COMMUNITY DEVELOPMENT DEPARTMENT REPORT

HEARING DATE: 10/8/2024

FROM: Sonya Allen, Associate Planner
208-884-5533
sallen@meridiancity.org

SUBJECT: [H-2024-0014](#)
Apex Farr –MDA, PP, RZ
(aka Pinnacle)

- iii. Landscape buffers to adjoining uses

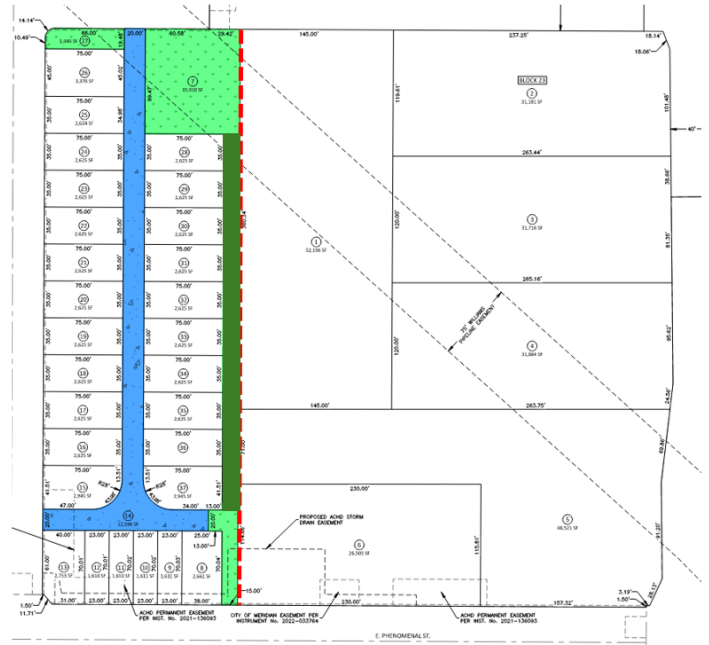
A 25-foot wide buffer is required in the C-C zoning district on Lots 1, 5 and 6, Block 23 to the abutting residential uses along the west boundary as set forth in UDC Table 11-2B-3.

Landscaping and fencing (if the use can't be adequately buffered by landscaping) is required within the buffer in accord with the standards listed in UDC [11-3B-9C](#).

The Applicant requests City Council approval of *no* buffer in this area with the provision of a 15-foot wide common area mew on the residential portion, which will include landscaping and a sidewalk as shown in the exhibit below. The Applicant asserts the mew will act as a buffer that still provides connectivity to the adjoining uses and walkability to the adjoining commercial uses to the east in accord with the MU-C FLUM designation. Staff recommends if Council is amendable to the Applicant's request that the common area mew is increased to a minimum of 20-foot wide consistent with the linear open space standards in UDC [11-3G-3B.1e](#) and includes landscaping in accord with the standards for landscape buffers to adjoining uses listed in UDC [11-3B-9C](#). If Council grants the request, a reduction to the buffer width shall not affect building setbacks; all structures shall be set back from the property line a minimum of the buffer width (i.e. 25-feet) required in the C-C zoning district.

As an alternative to the Applicant's request, ~~which would require no buffer on the C-C zoned property, Staff recommends a public street is provided between the residential and~~

commercial portions of Block 23 and an alley is provided for access to the residential units rather than a private street. The addition of a public street will provide a named street for addressing the east-facing units, provide for on-street parking for guests of the residential units and provide a transition/separation between land-uses and Staff's original recommendation to provide a public street between the residential and commercial uses, which doesn't meet ACHD's off-set requirements, Staff recommends residential lots/uses are removed from Block 23 and all of Block 23 is developed with commercial uses and zoned C-C. See concept layout below in Section III.E.1.

Traffic Calming – Bulb Outs and Choke Points:

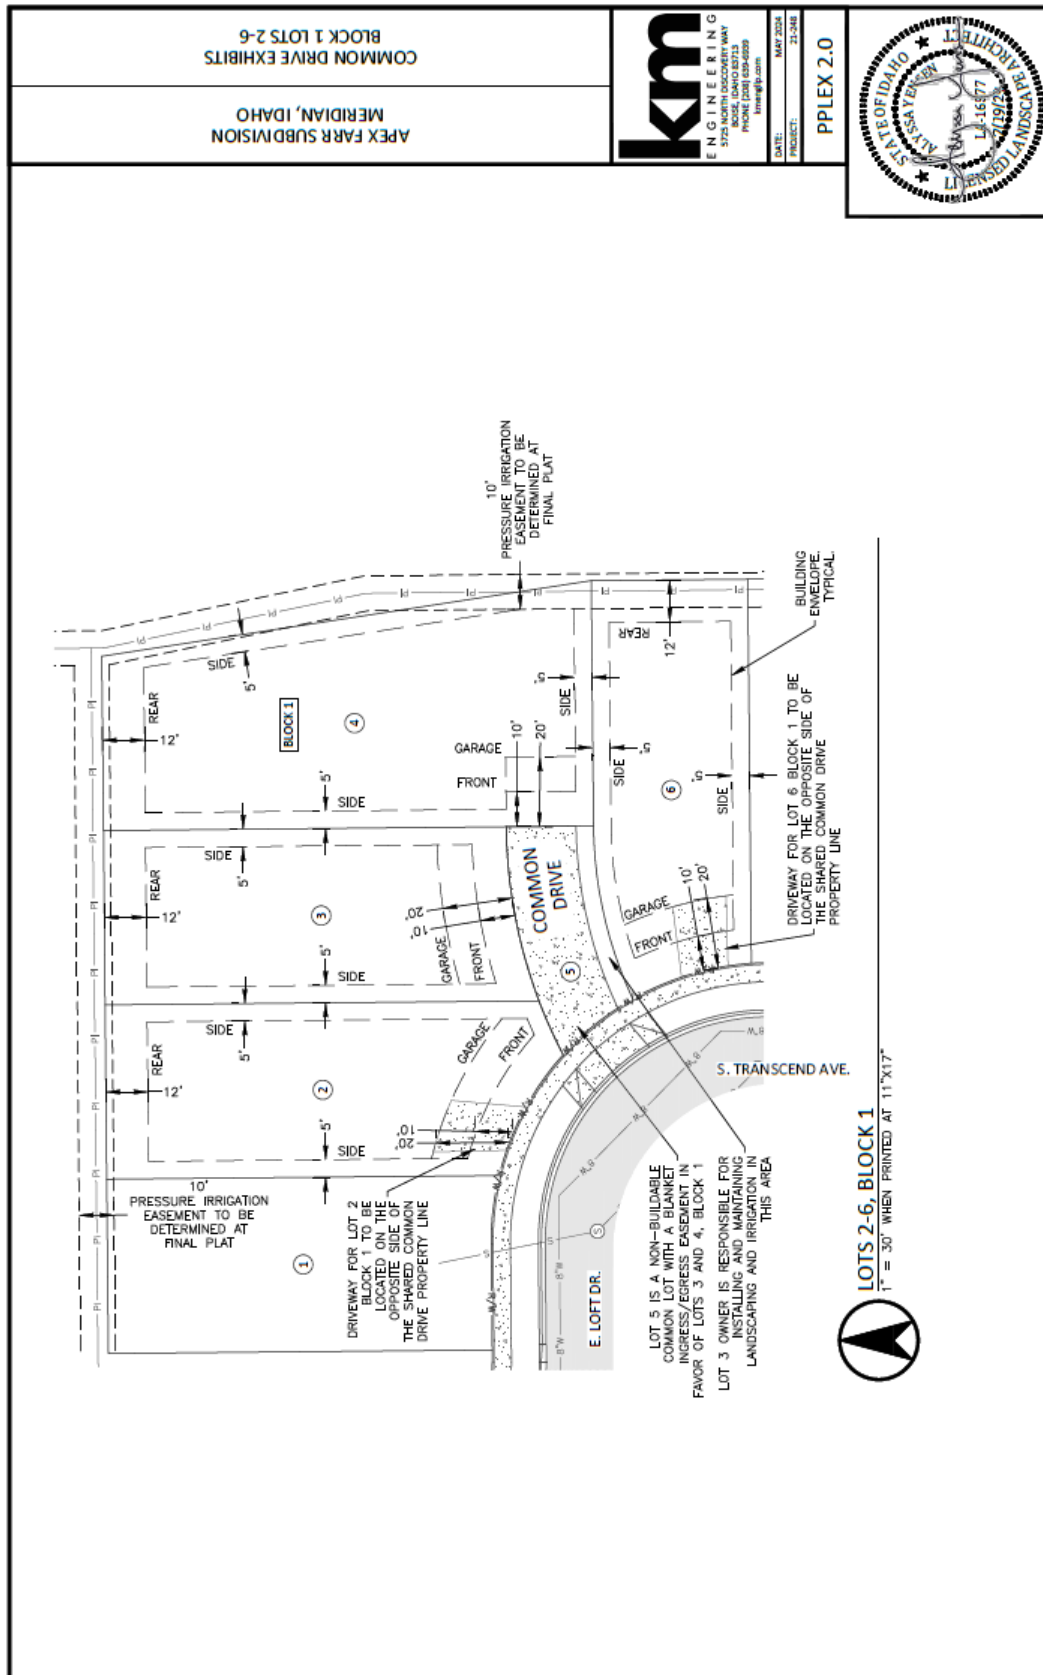
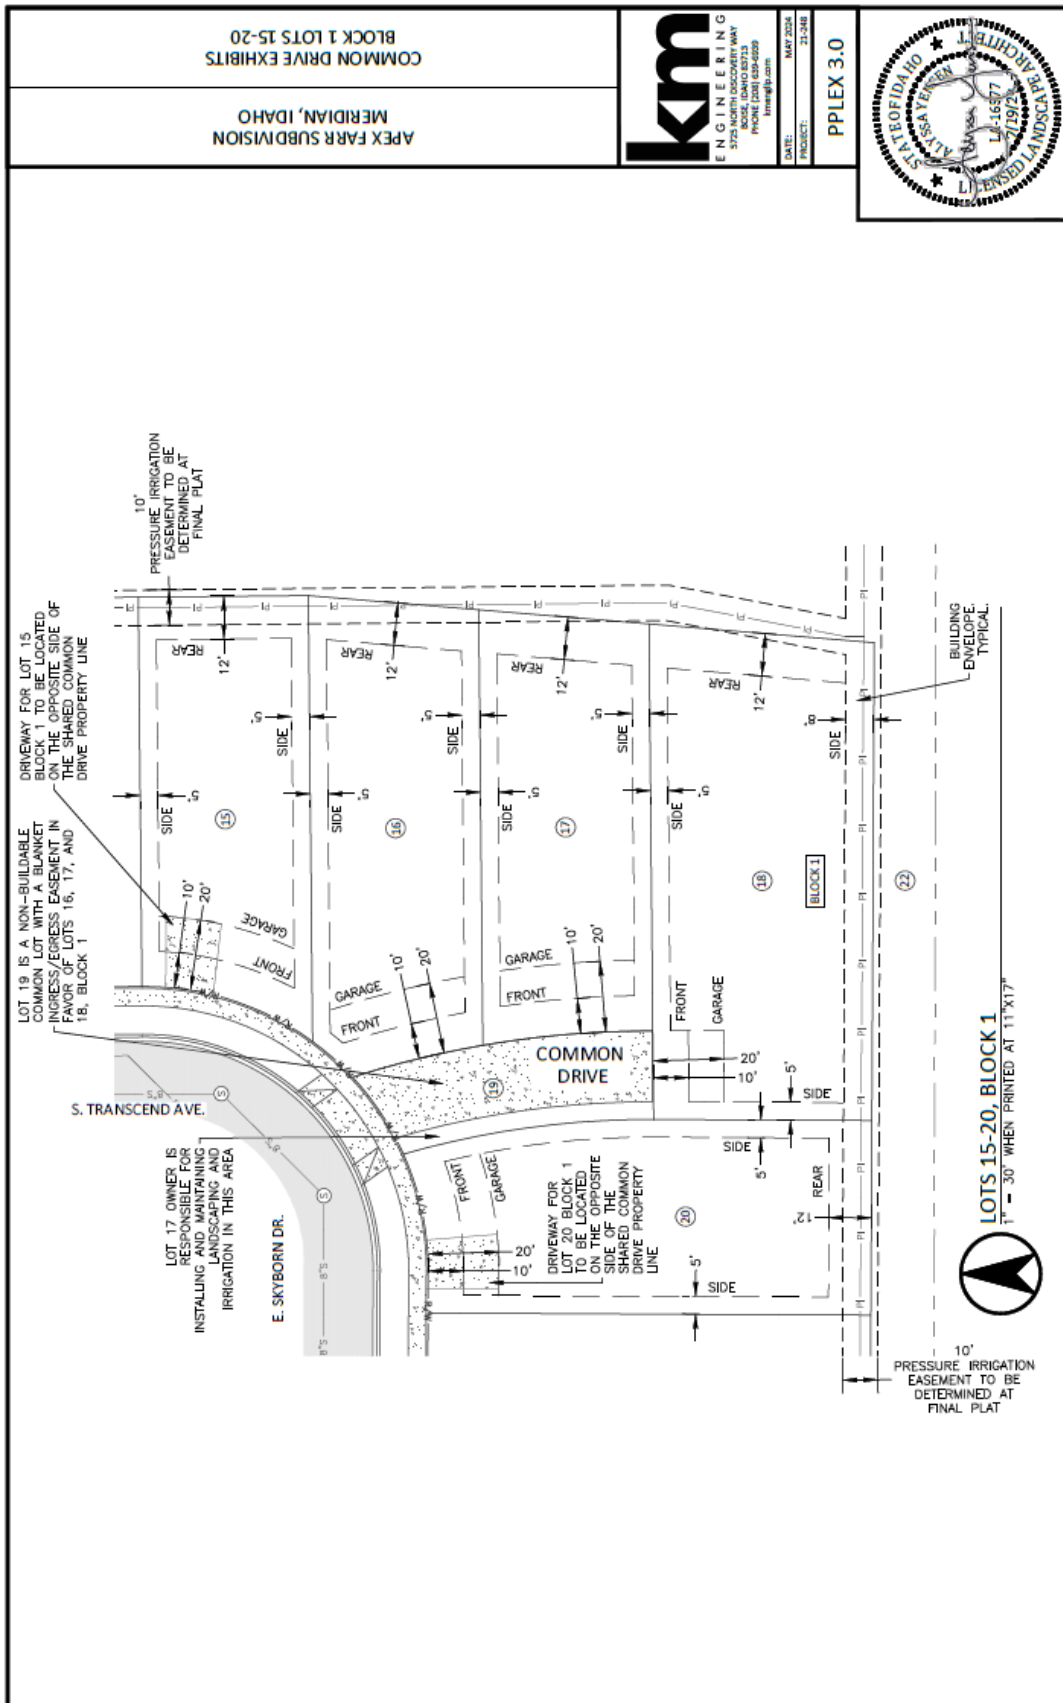
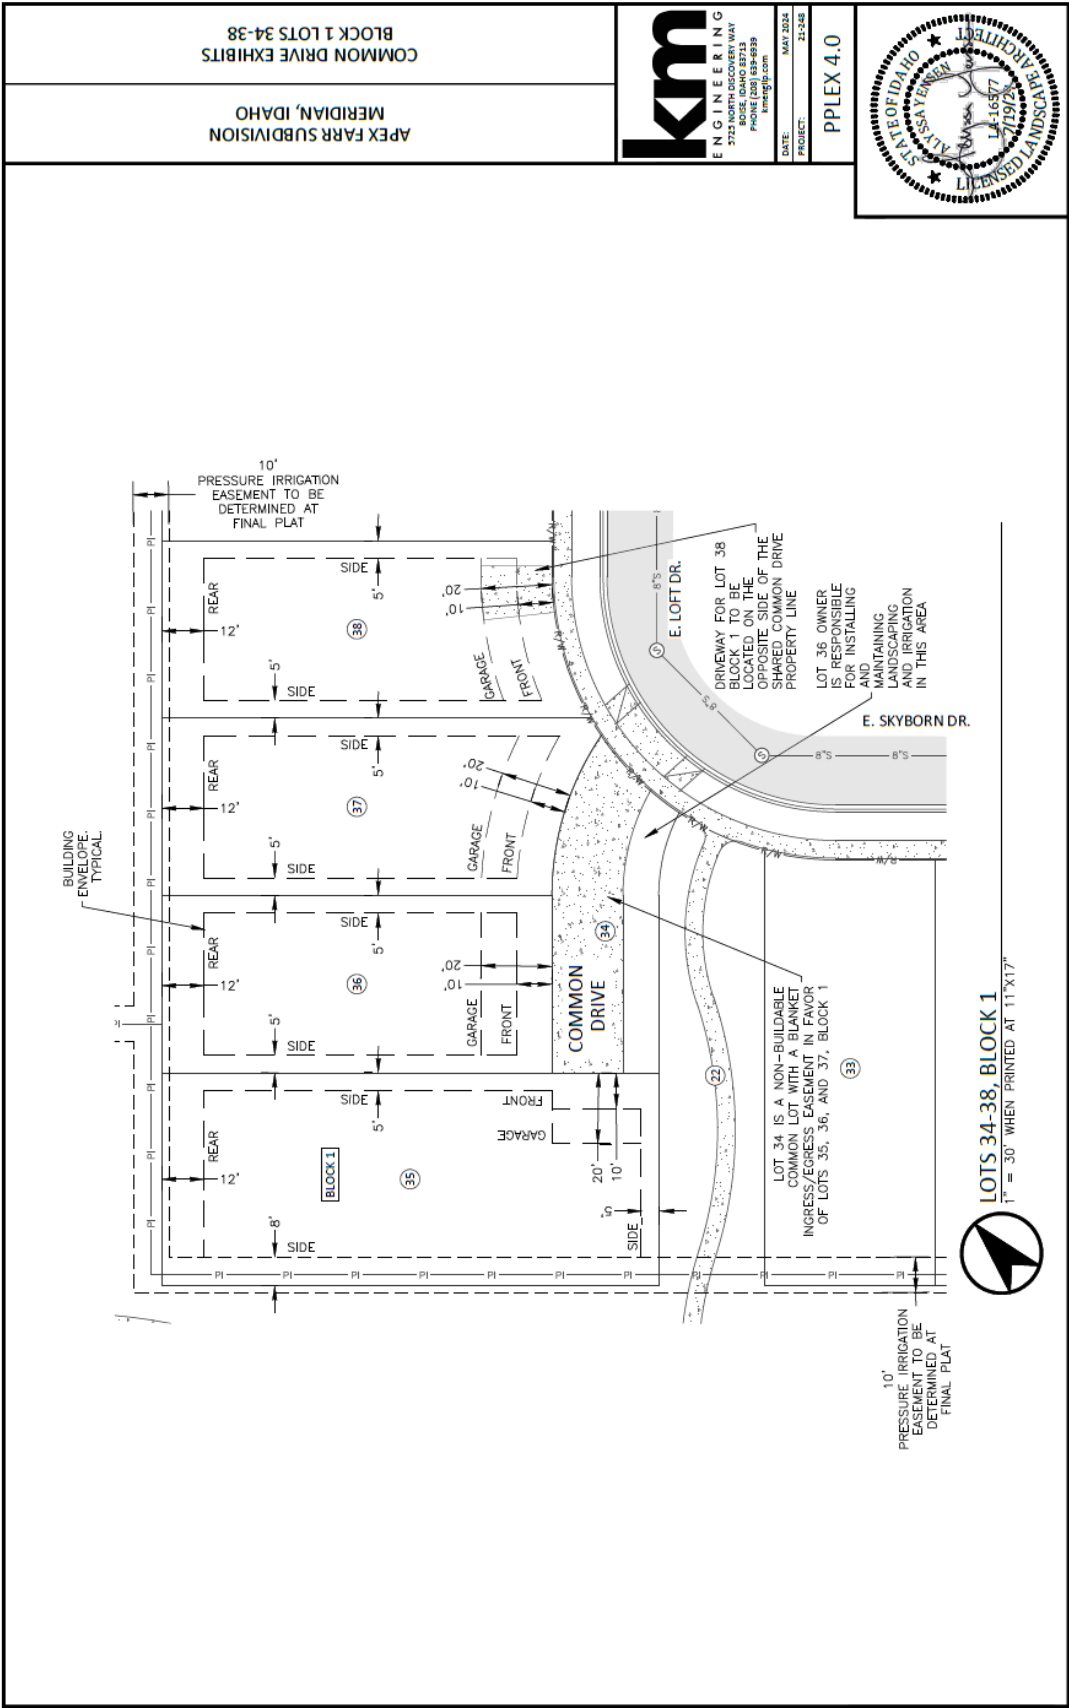
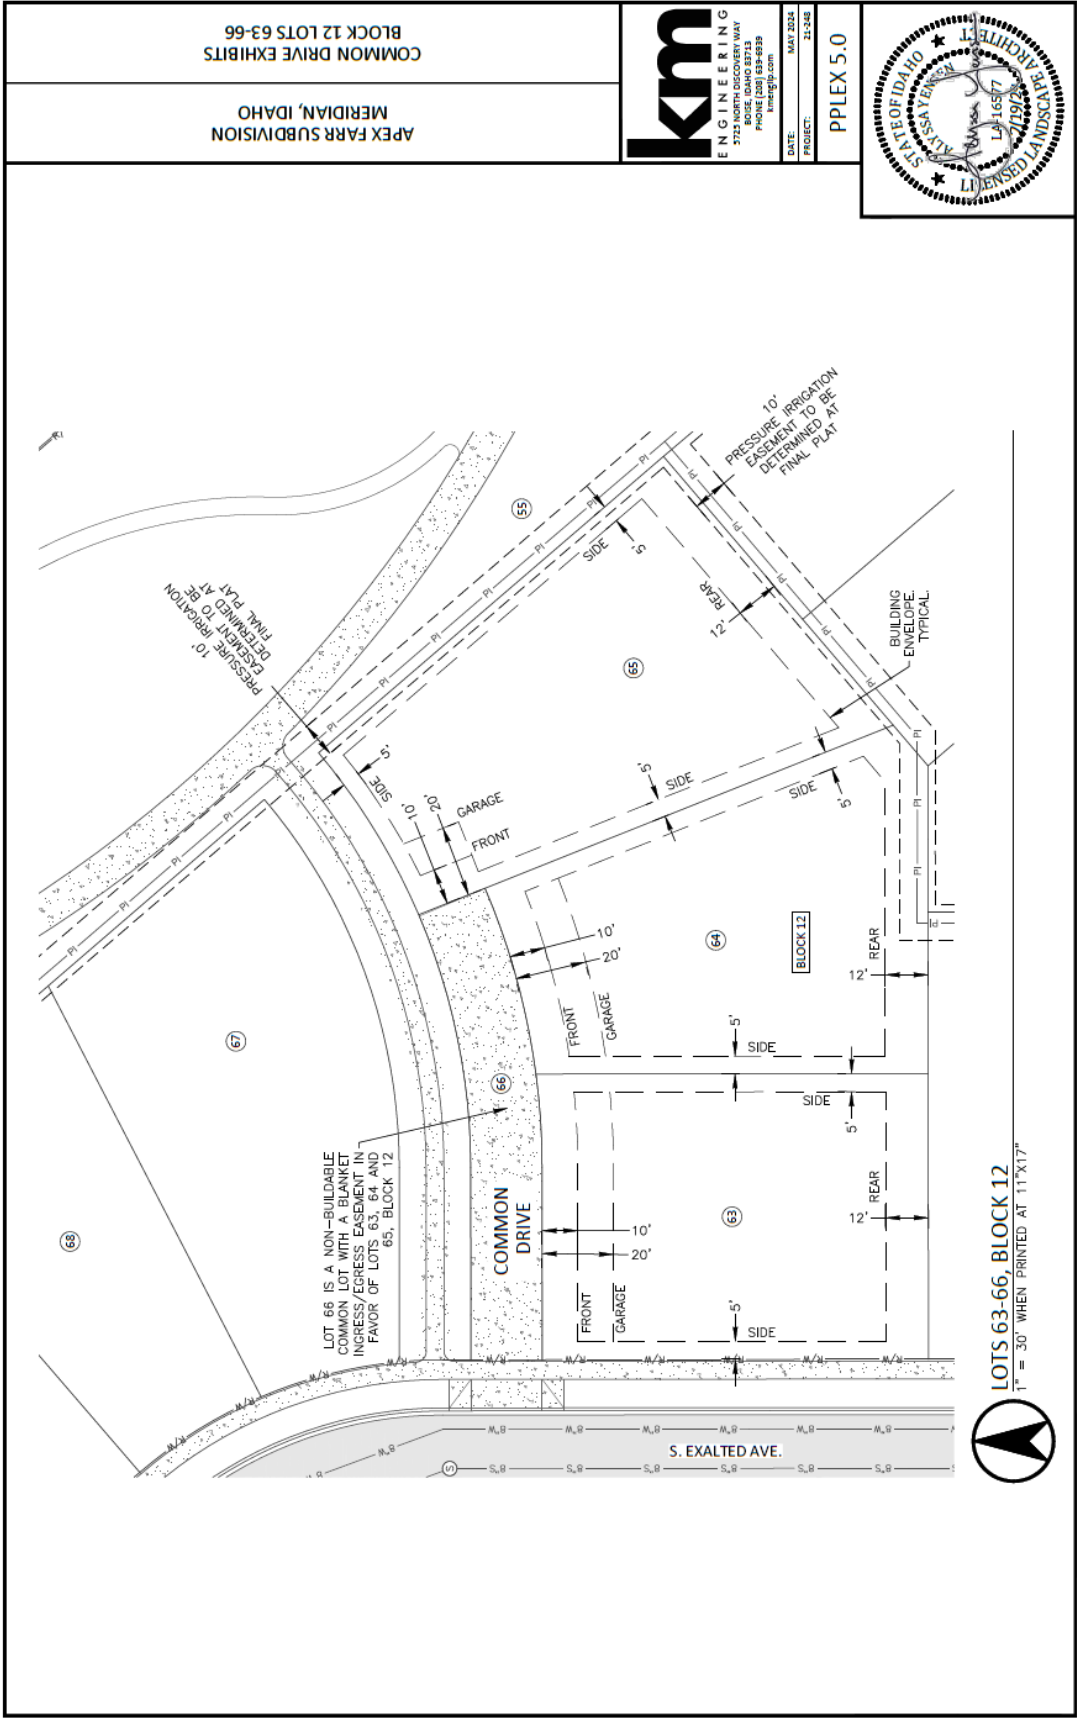
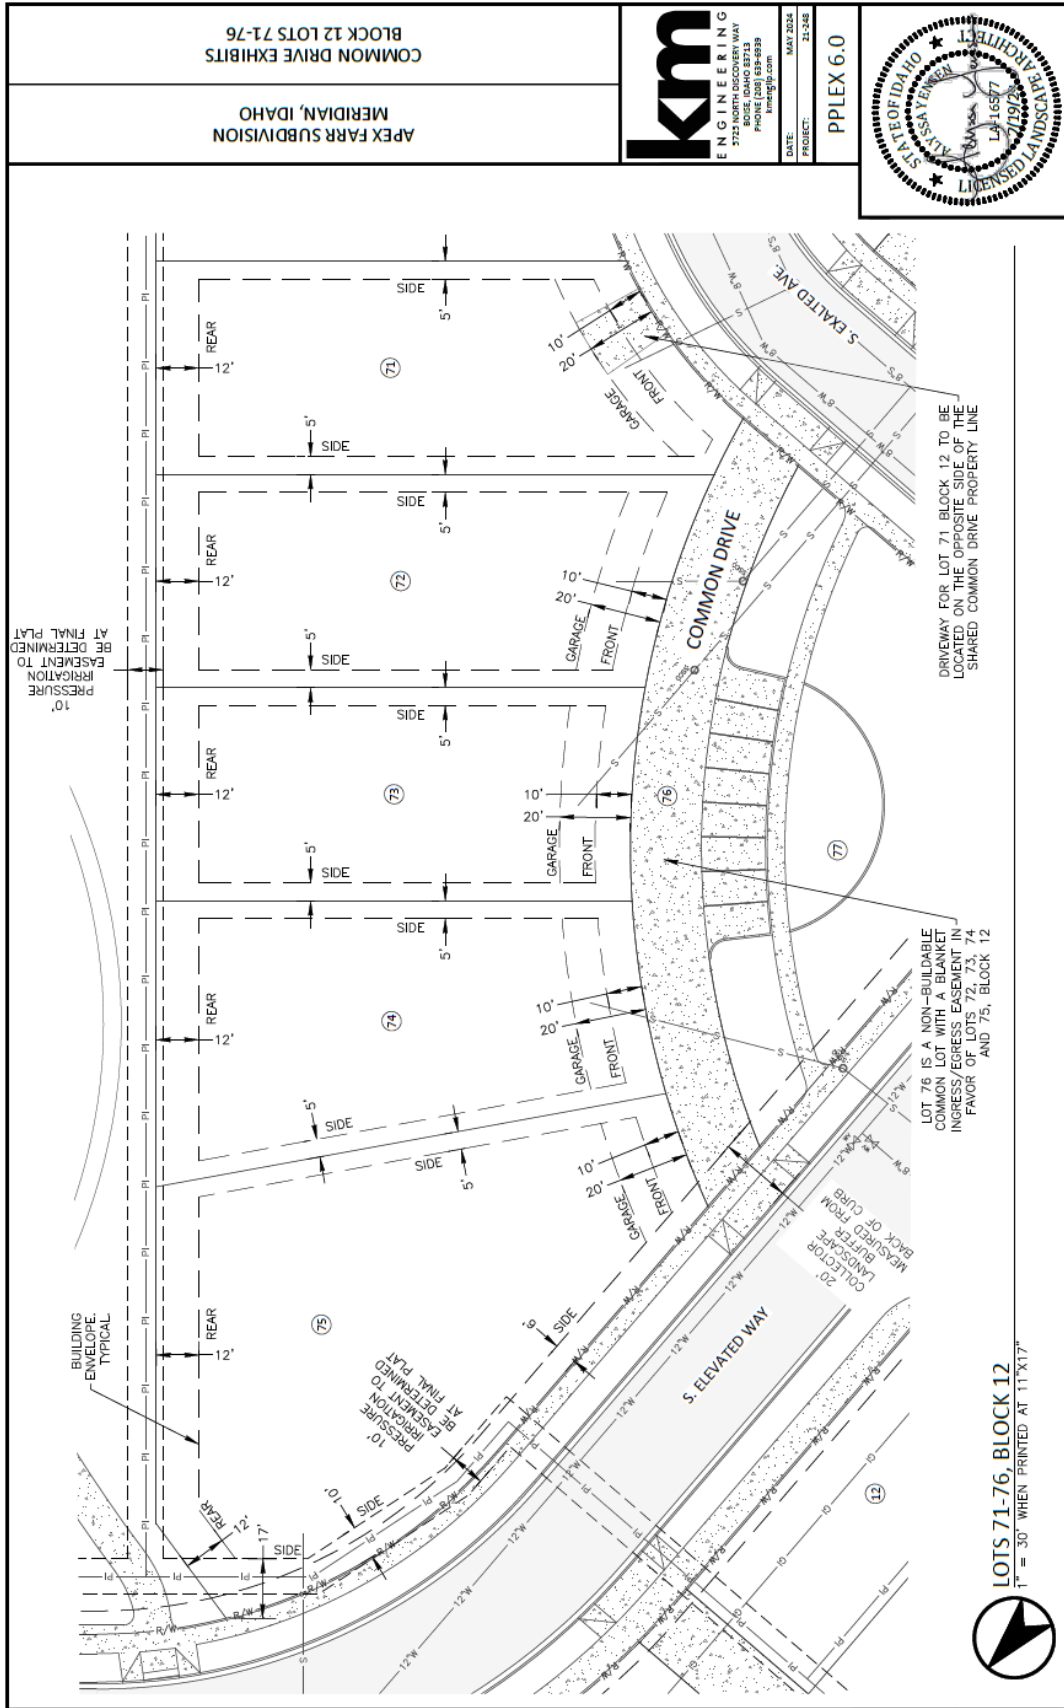
- The face of Block 12 along W. Precipice Dr. is approximately 2,500-feet. Two (2) pedestrian connections are proposed within the block that provides pedestrian access between streets. The Farr Lateral runs along the north side of W. Precipice Dr. at the highest point of the development.

- The face of Block 12 along W. Vertex Dr. is approximately 1,500-feet. One (1) pedestrian connection is proposed within the block that provides pedestrian access between streets.

The Applicant requests a Council waiver to the block face standard for both of these block faces based on the above-noted site constraints in addition to those noted in Section III.C1 above. Traffic calming is proposed in the form of a 29-foot wide street section for W. Precipice Dr. along the Farr Lateral

and bulb outs and choke points at pedestrian crossings as shown below. Note: The proposed reduced street section will only allow parking on one side of the street.
